SUBJECT: Forwards response to listed question re topical rept
DPC-NE-3003, "Mass & Energy Release & Containment Response
Methodology."

Subject: Oconee Nuclear Station
Docket Numbers 50-269, -270, and 287
Topical Report DPC-NE-3003, "Mass and Energy Release and
Containment Response Methodology"; Response to RAI

OCONEE MSLB/EQ ANALYSIS

VIKING LOCA Test Vs. MSLB Vapor Temp

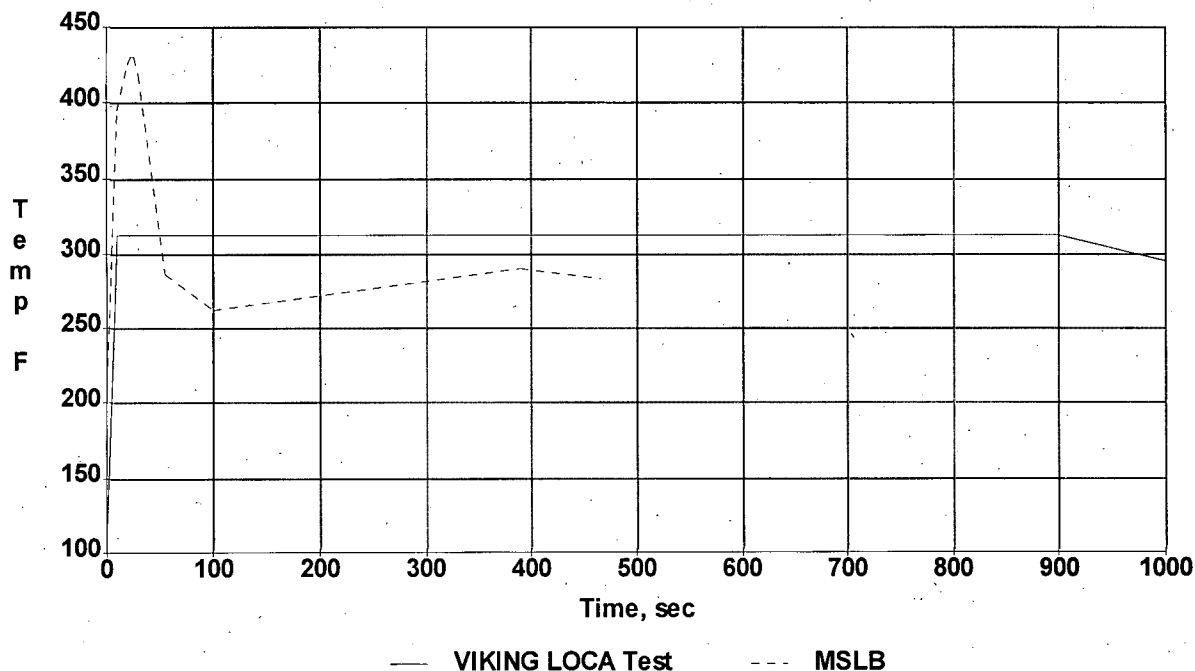
In a telephone call on June 1, 1994 between Len Wiens of the NRC and Scott Gewehr of Duke, regarding the subject topical report, a question was put forth regarding main steam line break temperature and equipment qualification in containment. Attached please find Duke's response to this question.

The Viking penetration was tested at a peak temperature of 312°F for the first 15 minutes, ramped down to 295°F for the next 45 minutes, and then held at 290°F for a further 23 hours. The Viking profile compared to the LOOP180 MSLB is shown below:

Additionally, the Viking penetration was thermally aged and irradiated prior to LOCA testing. The component parts were thermally aged to well over 60 years using Arrhenius methodology and irradiated to postulated LOCA doses ($>10^8$ rads) which are not present during a MSLB.
